DRAWN		MUSIC MAN INC. ANAHEIM, CA.
CHECKED		RD-50 AMPLIFIER SCHEMATIC DIAGRAM RD-50B BOARD
DESIGNED	T. WALKER	
APPROVED		SCALE
APPROVED		DWG. NO. 5004 REV. E
		SHEET 1 OF 1

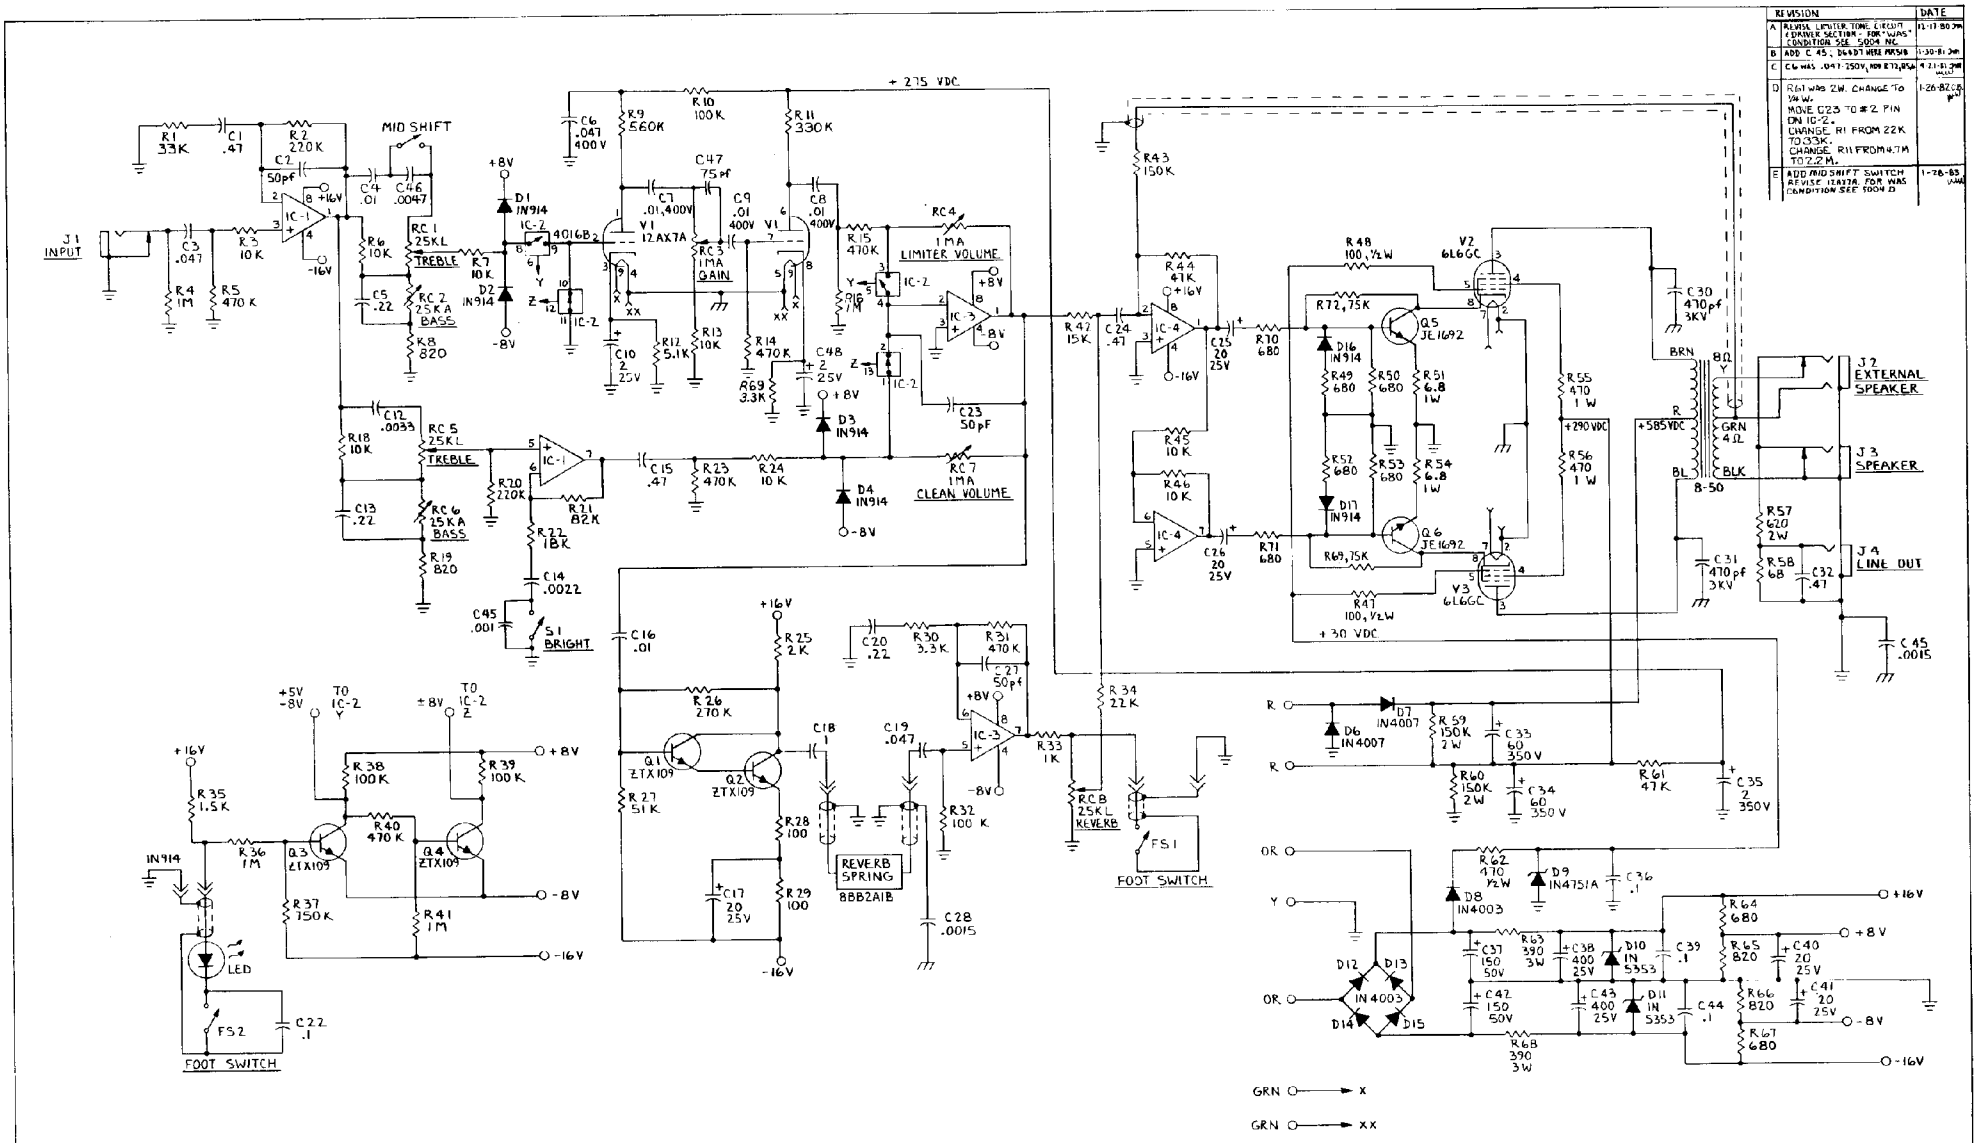
REVISION		DATE
A	REVISE LIMITER TONE CIRCUIT & DRIVER SECTION - FOR "WAS" CONDITION SEE 5004 NC	12-17-80 JMH
B	ADD C 45, .0047 HERE PER 5B	1-30-81 JMH
C	C6 WAS .047 250V, NOW R73, R54	4-21-81 JMH
D	R61 WAS 2W. CHANGE TO ½W. MOVE C23 TO #2 PIN ON IC-2. CHANGE R1 FROM 22K TO 33K. CHANGE R11 FROM 1M TO 2.2 M.	1-26-82 JMH
E	ADD MID SHIFT SWITCH REVISE 12AX7A FOR WAS CONDITION SEE 5004 D	1-28-83 JMH
